Appendix F: Facility Reports

Casa House - Exterior
40 West Olive Street, Madera

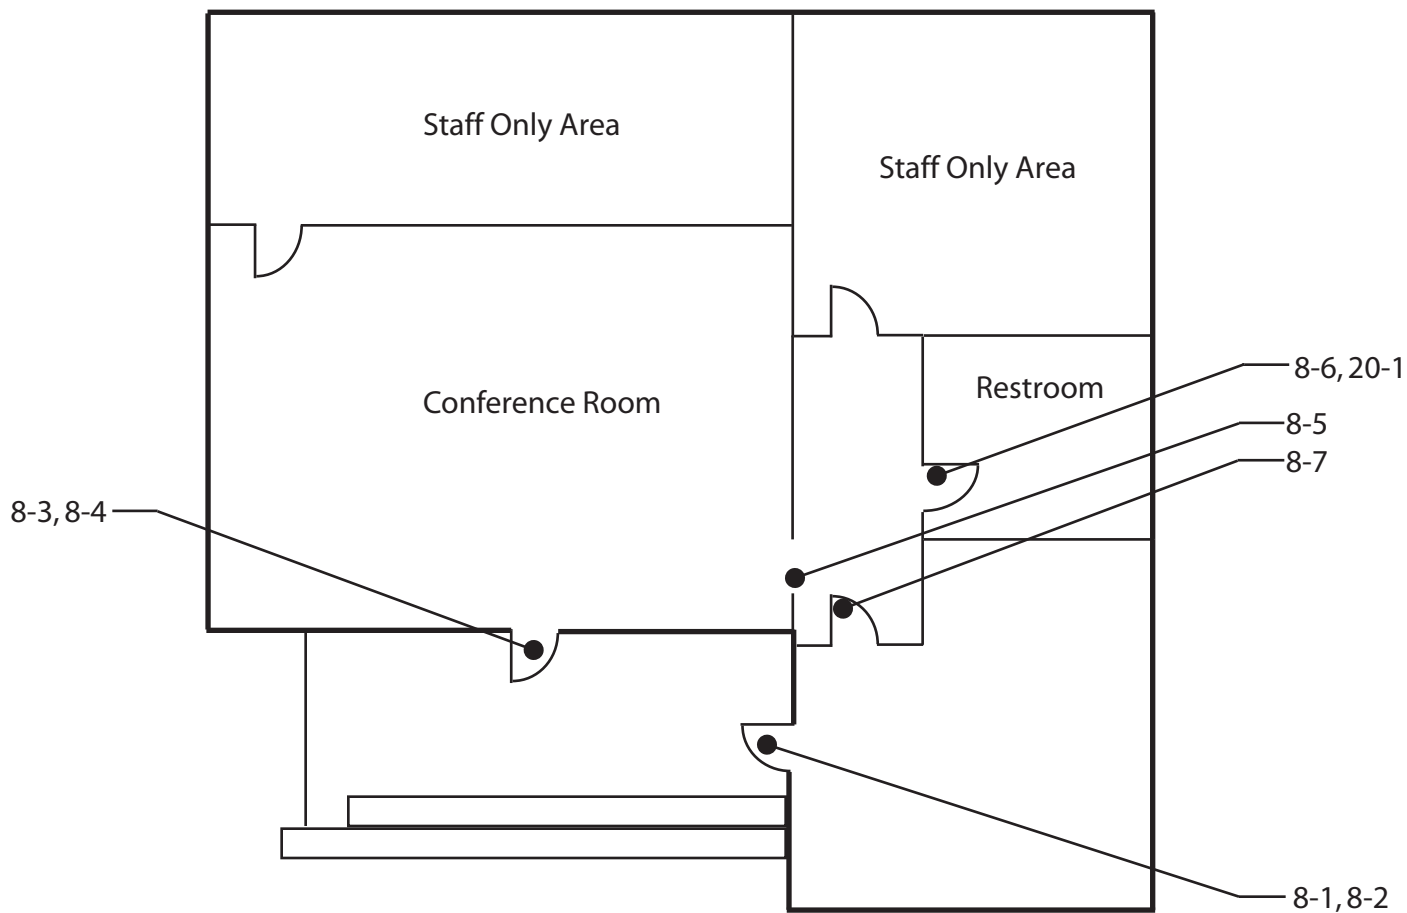
Exterior		
1 - 1	Parking Area	Priority: 4
Provide or modify accessible spaces		\$2,950
Notes: There are a total of 17 parking spaces and 0 accessible parking space. Provide 1 accessible parking space closest to the building entrance.		
State: 1129B		
Federal: 4.1.2(5)(b)		
6 - 1	Stairway	Priority: 4
Install or modify handrails		\$2,000
Notes: Handrails are not provided. There are 2 risers.		
State: 1133B.4.1.1		
Federal: 4.9.4		
Install tread striping		\$30
Notes: Indicator stripes are not provided. There are 2 risers.		
State: 1127B.4, 1133B.4.4		
Federal: -		
Replace stairs		\$750
Notes: Treads are not uniform. There are 2 risers.		
State: 1007.3, 1009.1, 1133B.4.5.3		
Federal: 4.9.2

Chamber of Commerce - Exterior
120 North East Way, Madera

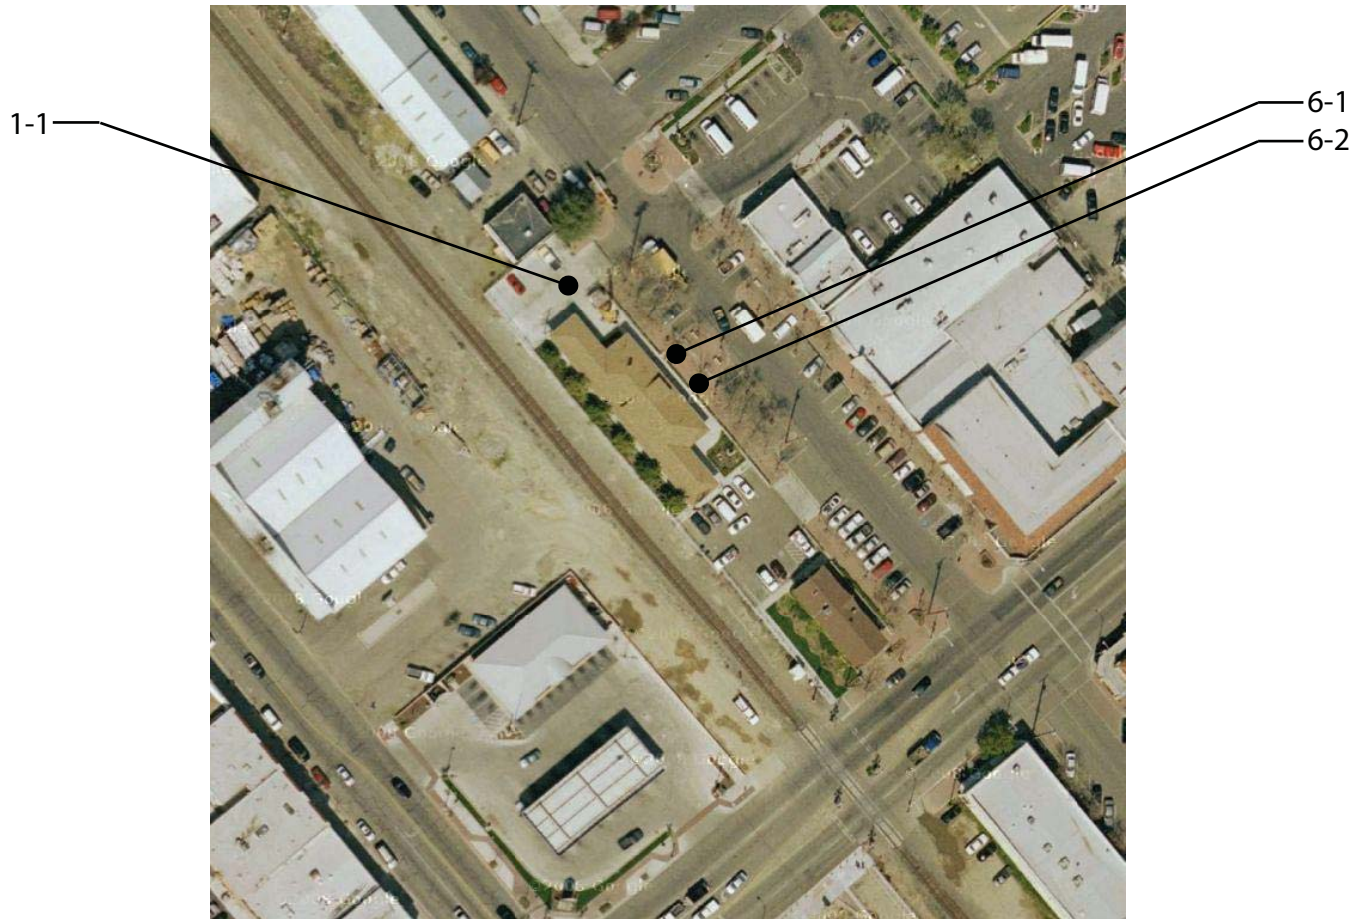
Exterior		
1 - 1	Parking Area	Priority: 1
Install sign		\$50
Notes: The words 'NO PARKING' are not painted in the one access aisle.		
State: 1129B.3 #1, 1129B.3 #2		
Federal: -		
Install sign		\$100
Notes: Additional sign stating "Minimum Fine \$250" is not provided in the accessible parking space.		
State: 1129B.4		
Federal: -		
Provide or modify accessible access aisles		\$150
Notes: Access aisle does not have blue borders.		
State: 1129B.3 #1, 1129B.4 #1		
Federal: 4.6.3		
Install sign for unauthorized parking		\$400
Notes: Tow-away sign does not provide contact information.		
State: 1129B.4, 1133B.8.6.3		
Federal: -		
Install van parking sign		\$250
Notes: Van accessible signage is not provided.		
State: 1129B.4		
Federal: 4.6.4		
Regrade surface		\$2,000
Notes: Slopes in the accessible parking space ranges from 2.5% to 6%. Relocate the parking space and access aisle to the right because slopes in those areas does not exceed 2%.

Exterior		
6 - 2	Stairway	Priority: 4
Install tread striping		\$45
Notes: Indicator stripes are not provided on exterior stairway. There are 3 risers.		
State: 1127B.4, 1133B.4.4		
Federal: -		
Install or modify handrails		\$2,400
Notes: Handrails are 32" (34" to 38") AFF. Bottom extensions do not extend 12" and one tread width. There are 3 risers.		
State: 1133B.4.2.1, 1133B.4.2.2		
Federal: 4.9.4 #2, 4.9.4 #5

Chamber of Commerce - First Floor
120 E Street, Madera

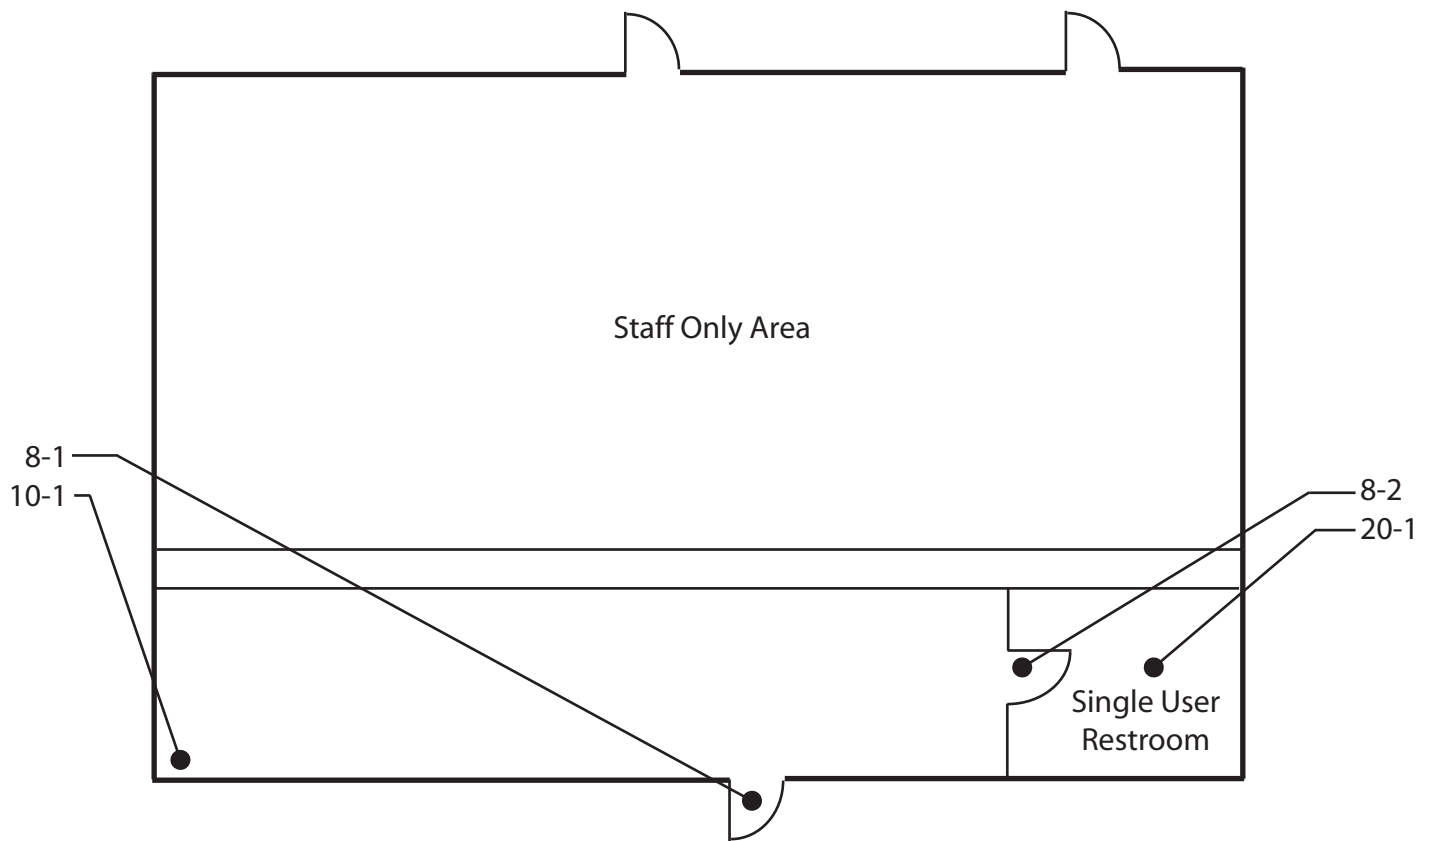
Floor 1		
8 - 1	Door/Gate	Priority: 1
Provide sign(s) indicating accessible entries and facilities		\$100
Notes: International Symbol of Accessibility is not provided at the accessible entrance.		
State: 1117B.5.8.1.2, 1127B.3		
Federal: 4.13.6		
Install or modify permanent room signs		\$250
Notes: There is an exit sign but Braille is not provided.		
State: 1011.3 #3		
Federal: -		
8 - 2	Door/Gate	Priority: 2
Adjust door closer		\$100
Notes: Operating effort is 6 lbs (5 lbs max).		
State: 1133B.2.5		
Federal: 4.13.11		
10 - 1	Drinking Fountain	Priority: 3
Replace or reposition drinking fountain		\$3,500
Notes: Hi-low drinking fountain is not provided.		
State: 1115B.4.6 #1		
Federal: 4.1.6

Floor 1		
20 - 1	Single User Restroom	Priority: 2
Install sign		\$250
Notes: California required signage is not provided.		
State: 1115B.6		
Federal: 4.30.4		
Install sign		\$250
Notes: Federal required signage is not provided on the latch side of the door. ISA not provided.		
State: 1115B.6, 1117B.5.1 #1, 1117B.5.5 #3, 1117B.5.8.1.2		
Federal: 4.30.4		
Replace or reposition dispensers or mirrors		\$200
Notes: Mirror is mounted so bottom of reflecting surface is 45" (40" max) AFF.		
State: 1115B.8.1		
Federal: 4.19.6		
Replace or reposition dispensers or mirrors		\$250
Notes: Towel dispenser is 56" (40" max) AFF. Lower towel dispenser.		
State: 1115B.8.3		
Federal: 4.23.7		
Replace or reposition dispensers or mirrors		\$100
Notes: Seat cover dispenser is 45" (40" max) AFF. Lower seat cover dispenser.		
State: 1115B.8.3		
Federal: 4.23.7		
Replace or modify grab bars		\$350
Notes: Side grab bar is centered 33-1/4" (33" absolute) AFF. Side grab bar is positioned so the front end is 50" (54" min) from the back wall. Side grab bar is 20" (24" min) in front of the toilet.

City Hall - Exterior
205 West 4th Street, Madera

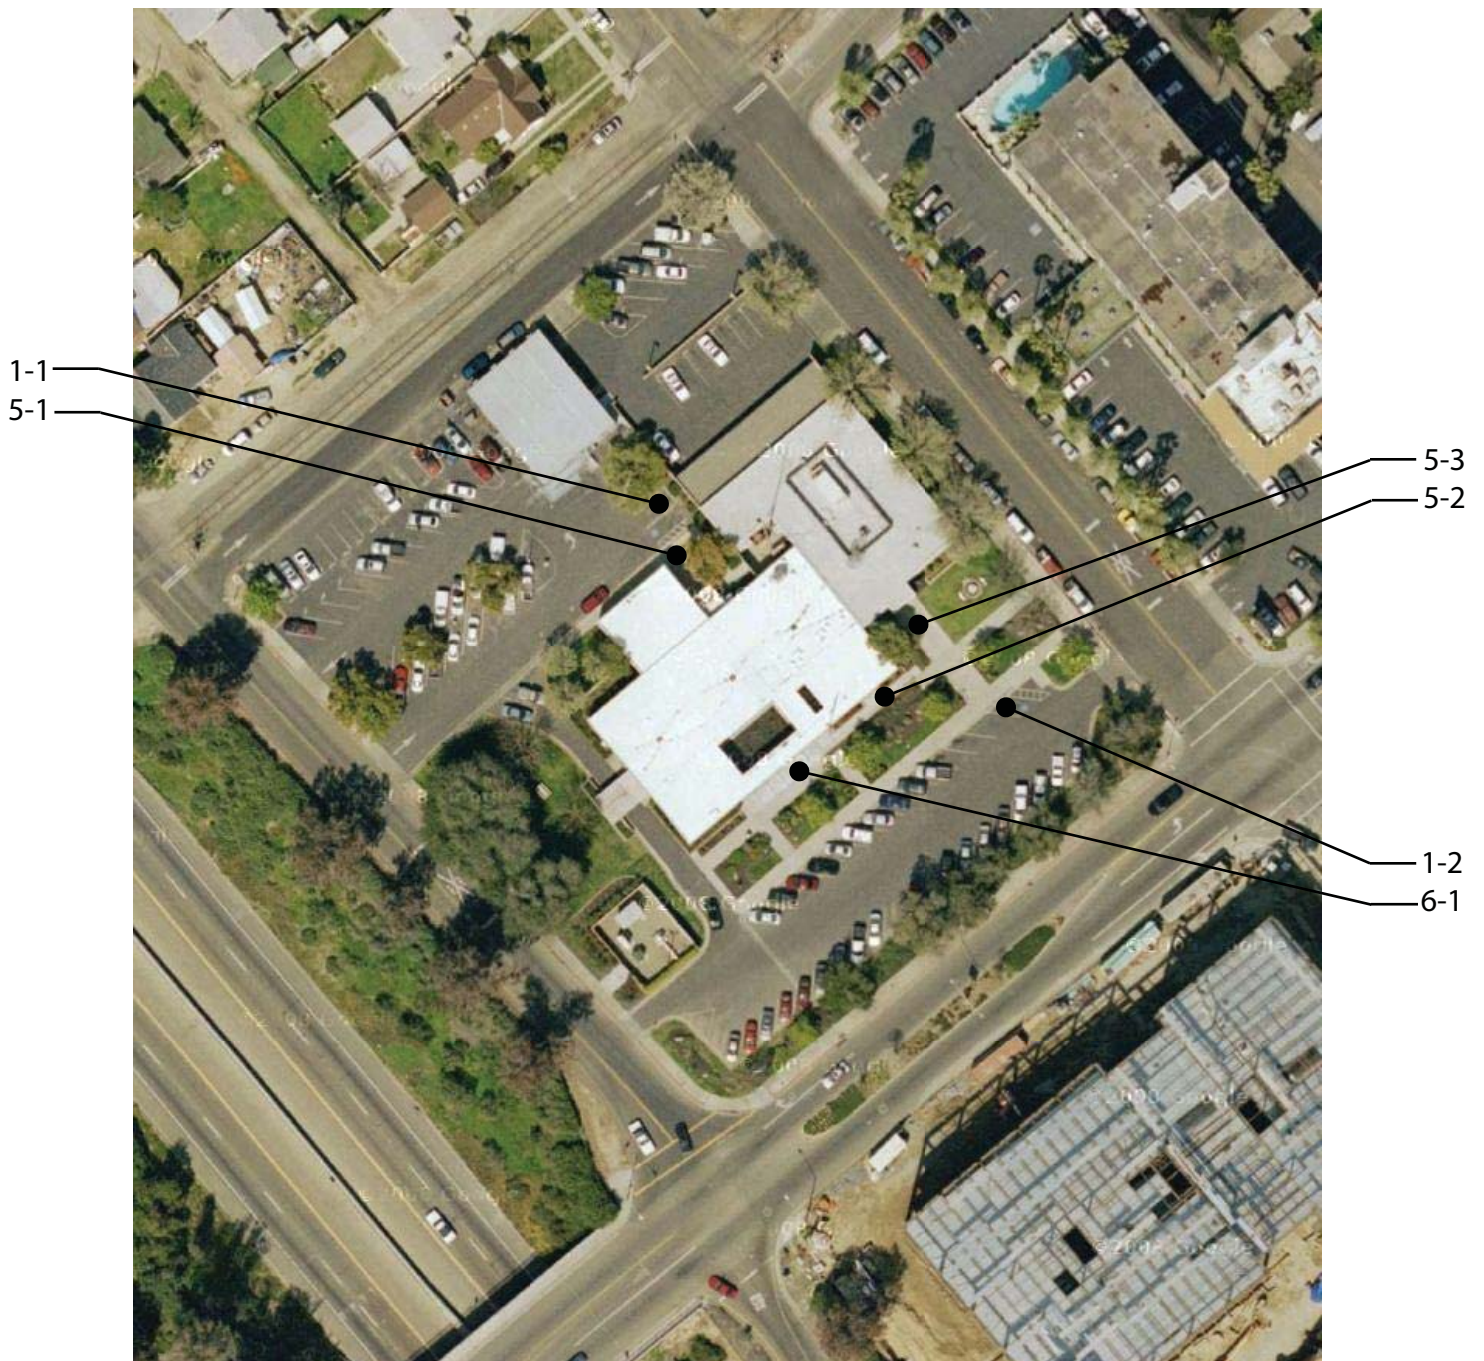
Exterior		
1 - 1	Parking Area	Priority: 1
Provide an accessible path of travel		\$2,000
Notes: There is one accessible parking space that requires the wheelchair user to walk behind another parked vehicle, other than their own to access the primary entrance.		
State: 1129B.3 #3		
Federal: -		
Install sign		\$200
Notes: Reflectorized signs are mounted 67" (80" min) AFF. Raise 2 signs.		
State: 1129B.4		
Federal: -		
Install sign for unauthorized parking		\$400
Notes: Warning sign is not provided.		
State: 1129B.4, 1133B.8.6.3		
Federal: -		
Provide or modify accessible spaces		\$250
Notes: Stall width is 8'4" (9' min) for 1 of the accessible parking spaces.		
State: 1129B.4 #1		
Federal: 4.6.3		
Provide or modify accessible access aisles		\$150
Notes: Access aisle does not have blue borders.		
State: 1129B.3 #1, 1129B.4 #1		
Federal: 4.6.3		
Install sign		\$200
Notes: Additional sign stating "Minimum Fine \$250" not provided for the 2 accessible parking spaces.

Exterior		
1 - 2	Parking Area	Priority: 1
Provide or modify accessible access aisles		\$150
Notes: Access aisle does not have blue borders and is faded. Repaint.		
State: 1129B.3 #1, 1129B.4 #1		
Federal: 4.6.3		
Install sign		\$200
Notes: Additional sign stating "Minimum Fine \$250" not provided for the 2 accessible parking spaces.		
State: 1129B.4		
Federal: -		
Install sign		\$50
Notes: The words 'NO PARKING' is faded in the access aisle. Repaint.		
State: 1129B.3 #1, 1129B.3 #2		
Federal: -		
Regrade surface		\$1,800
Notes: Slope in one of the accessible parking spaces is 3% (2% max). Regrade slope in accessible parking space.		
State: 1129B.3 #4		
Federal: 4.6.3		
5 - 1	Ramp	Priority: 1
Provide level landing		\$2,000
Notes: Bottom landing has a slope of 7.2% (2% max). Ramp is 24'4" long and 11' wide. Surface material is concrete.		
State: 1133B.5.4.1, 1133B.5.4.2		
Federal: 4.8.4 #3		
Install or modify handrails		\$10,000

Notes: Handrail is only provided on one side. Handrail top surface is mounted 33" (34" to 38") AFF. Handrail diameter is 2-1/2" (1-1/4" to 1-1/2").		
State: 1133B.5.5.1		
Federal: 4.26.2, 4.8.5 #1, 4.8.5 #5		
5 - 2	Ramp	Priority: 1
Install or modify handrails		\$10,000
Notes: Handrail is only provided on one side, however the dimensions do not meet ADA requirements. Provide handrails on both sides. Ramp is 52' long and 4' wide. Surface material is concrete.		
State: 1133B.5.5.1		
Federal: 4.26.2, 4.8.5 #1, 4.8.5 #5

Exterior		
5 - 3	Ramp	Priority: 1
Install or modify handrails		\$6,400
Notes: Handrail is only provided on one side. Provide handrails on both sides. Ramp is 31'7" long and 14'2" wide. Surface material is concrete.		
State: 1133B.5.5.1		
Federal: 4.8.5 #1		
6 - 1	Stairway	Priority: 1
Install tread striping		\$360
Notes: Indicator stripes are not provided. There are 6 sets of stairs, each with 4 risers.		
State: 1127B.4, 1133B.4.4		
Federal: -

City Hall - First Floor
205 West 4th Street, Madera

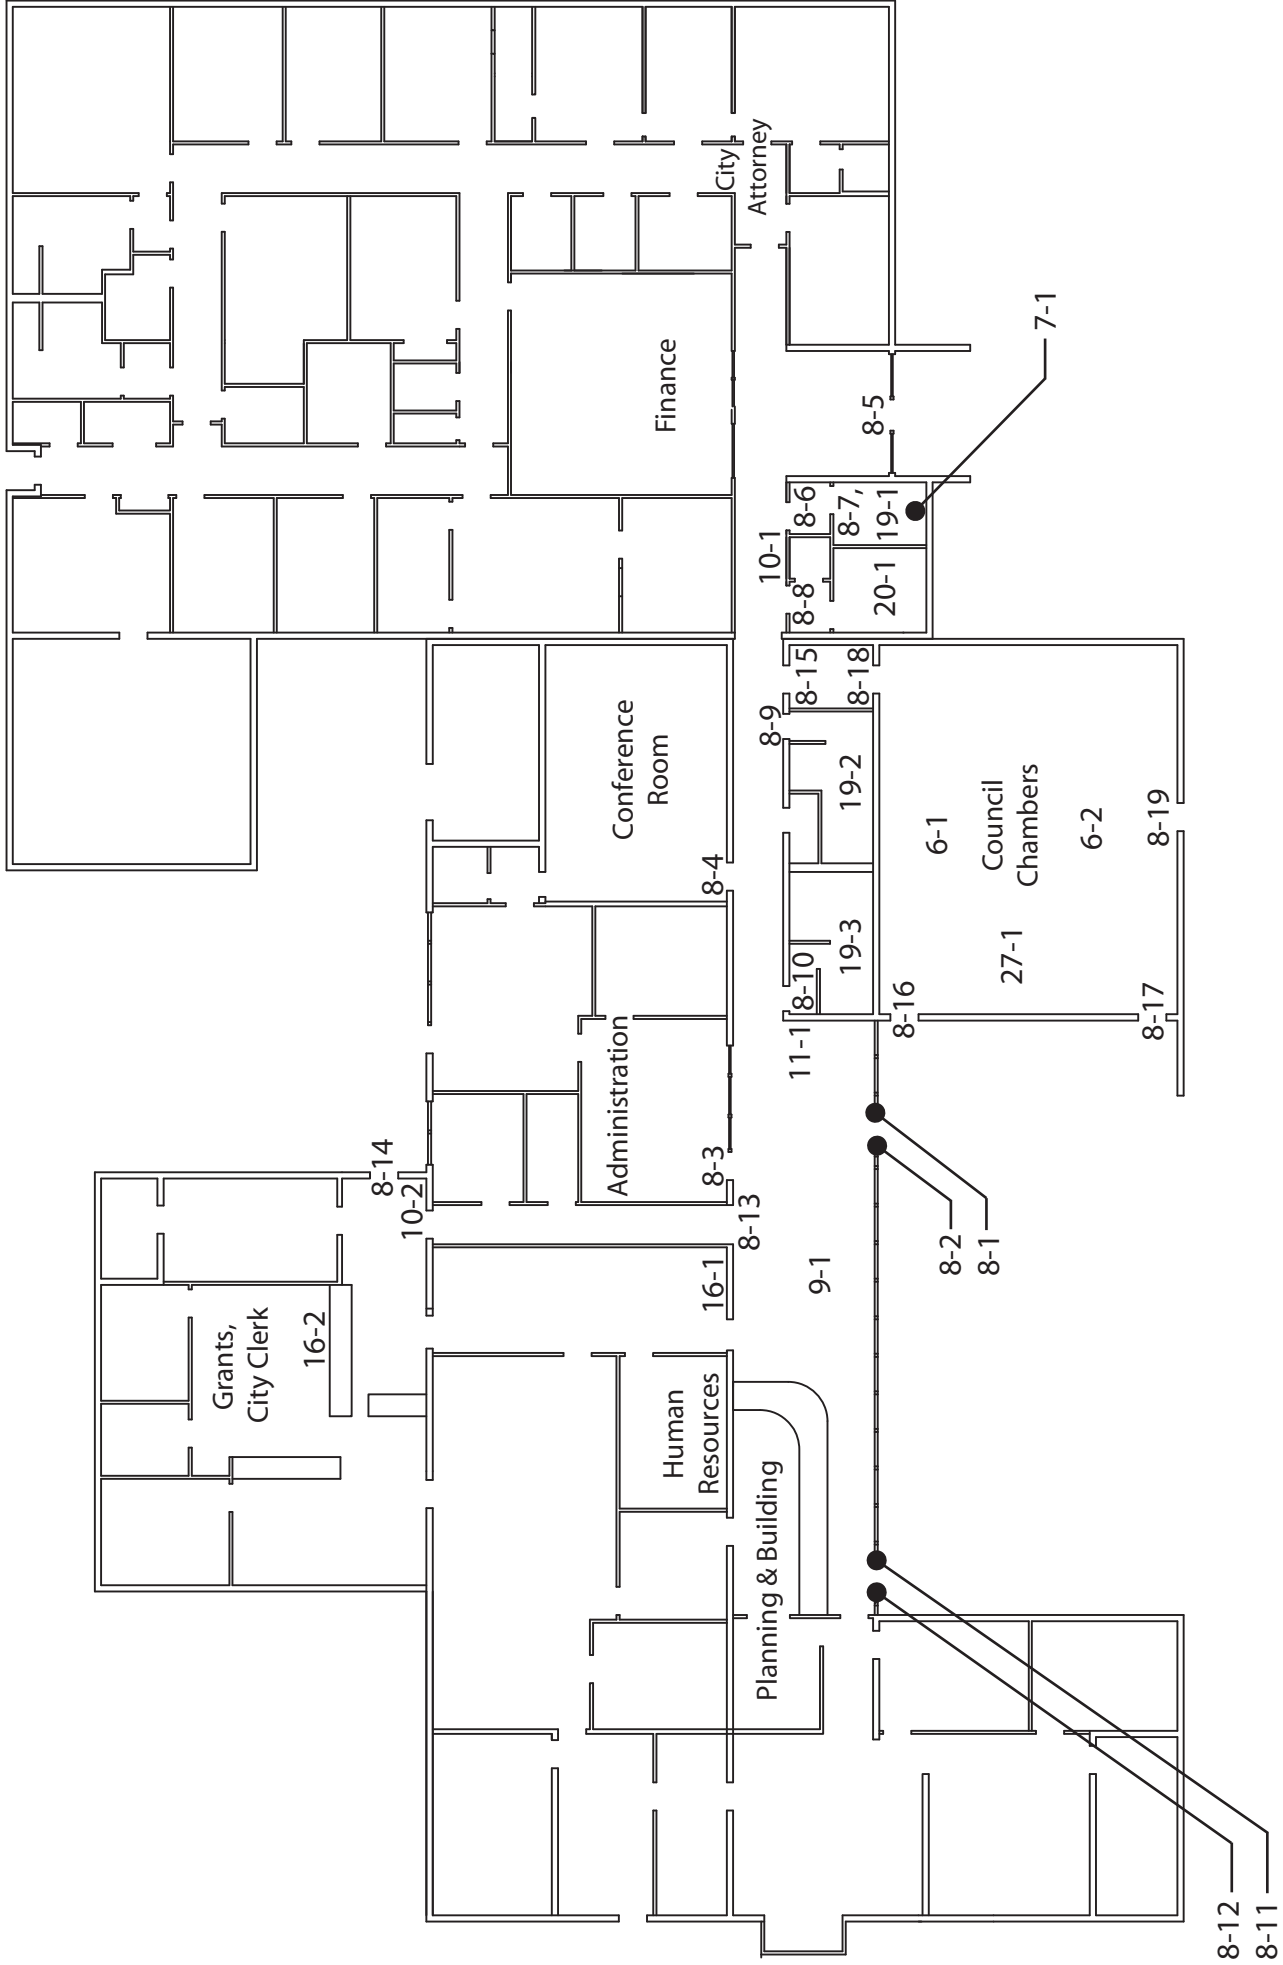
Floor 1		
6 - 1	Stairway	Priority: 2
Install tread striping		\$30
Notes: Indicator stripes are not provided. There are 3 risers.		
State: 1133B.4.4		
Federal: -		
Install or modify handrails		\$1,500
Notes: Handrail is not provided on one side. Bottom extensions are not provided. There are 3 risers.		
State: 1133B.4.1.1, 1133B.4.2.2		
Federal: 4.9.4, 4.9.4 #2		
6 - 2	Stairway	Priority: 2
Install tread striping		\$30
Notes: Indicator stripes are not provided. There are 3 risers.		
State: 1133B.4.4		
Federal: -		
Install or modify handrails		\$1,500
Notes: Handrail is not provided on one side. Bottom extensions are not provided. There are 3 risers.		
State: 1133B.4.1.1, 1133B.4.2.2		
Federal: 4.9.4, 4.9.4 #2		
7 - 1	Hazard	Priority: 4
Remove overhanging or protruding objects		\$100
Notes: Ashtry dispenser protrudes 5" (4" max) and is 47" (not between 27" to 80") AFF. Relocate or remove ashtray dispenser.		
State: 1133B.8.6.1

Federal: 4.4.1		
8 - 1	Door/Gate	Priority: 1
Adjust door closer		\$100
Notes: Operating effort is 15 lbs (5 lbs max).		
State: 1133B.2.5		
Federal: 4.13.11		
Provide sign(s) indicating accessible entries and facilities		\$100
Notes: Accessible entry not marked by the International Symbol of Accessibility.		
State: 1117B.5.8.1.2, 1127B.3		
Federal: 4.13.6

Floor 1		
8 - 2	Door/Gate	Priority: 1
Adjust door closer		\$100
Notes: Operating effort is 13 lbs (5 lbs max).		
State: 1133B.2.5		
Federal: 4.13.11		
8 - 3	Door/Gate	Priority: 4
Provide or modify door kickplate		\$100
Notes: Doorstop is mounted on kickplate. Kickplate is 4" (10" min) high.		
State: 1133B.2.6		
Federal: -		
8 - 4	Door/Gate	Priority: 2
Provide or modify door kickplate		\$100
Notes: Doorstop is mounted on kickplate.		
State: 1133B.2.6		
Federal: -		
Install or modify permanent room signs		\$250
Notes: There is an exit sign but Braille is not provided.		
State: 1011.3 #3		
Federal: -		
8 - 5	Door/Gate	Priority: 1
Adjust door closer		\$100
Notes: Operating effort is 8 lbs (5 lbs max).		
State: 1133B.2.5		
Federal: 4.13.11		
Provide sign(s) indicating accessible entries and facilities		\$100
Notes: Accessible entry not marked by the International Symbol of Accessibility.		
State: 1117B.5.8.1.2, 1127B.3

Floor 1		
8 - 6	Door/Gate	Priority: 4
Adjust door closer		\$100
Notes: Operating effort is 6 lbs (5 lbs max).		
State: 1133B.2.5		
Federal: 4.13.11		
Increase or provide maneuvering or clear floor area		\$2,500
Notes: Level space on swing-side is 58" (60" min).		
State: 1133B.2, 1133B.2.4.2, 1133B.7.5		
Federal: 4.13.6		
8 - 7	Door/Gate	Priority: 4
Adjust door closer		\$100
Notes: Operating effort is 13 lbs (5 lbs max).		
State: 1133B.2.5		
Federal: 4.13.11		
8 - 8	Door/Gate	Priority: 2
Adjust door closer		\$100
Notes: Operating effort is 12 lbs (5 lbs max).		
State: 1133B.2.5		
Federal: 4.13.11		
8 - 9	Door/Gate	Priority: 4
Adjust door closer		\$100
Notes: Operating effort is 11 lbs (5 lbs max).		
State: 1133B.2.5		
Federal: 4.13.11		
Enlarge door opening		\$3,500
Notes: Width of clear opening is 29" (32" min).		
State: 1133B.2.2, 1133B.2.3		
Federal: 4.13.5		
Provide additional strike edge clearance		\$3,000
Notes: Strike-edge clearance on swing-side is 1" (18" min).

Floor 1		
8 - 10	Door/Gate	Priority: 4
Adjust door closer		\$100
Notes: Operating effort is 11 lbs (5 lbs max).		
State: 1133B.2.5		
Federal: 4.13.11		
Enlarge door opening		\$3,500
Notes: Width of clear opening is 30" (32" min).		
State: 1133B.2.2, 1133B.2.3		
Federal: 4.13.5		
Increase or provide maneuvering or clear floor area		\$2,500
Notes: Level space on swing-side is 32" (60" min).		
State: 1133B.2, 1133B.2.4.2, 1133B.7.5		
Federal: 4.13.6		
8 - 11	Door/Gate	Priority: 1
Adjust door closer		\$100
Notes: Operating effort is 13 lbs (5 lbs max).		
State: 1133B.2.5		
Federal: 4.13.11		
Provide sign(s) indicating accessible entries and facilities		\$100
Notes: Accessible entry not marked by the International Symbol of Accessibility.		
State: 1117B.5.8.1.2, 1127B.3		
Federal: 4.13.6		
8 - 12	Door/Gate	Priority: 1
Adjust door closer		\$100
Notes: Operating effort is 14 lbs (5 lbs max).		
State: 1133B.2.5		
Federal: 4.13.11
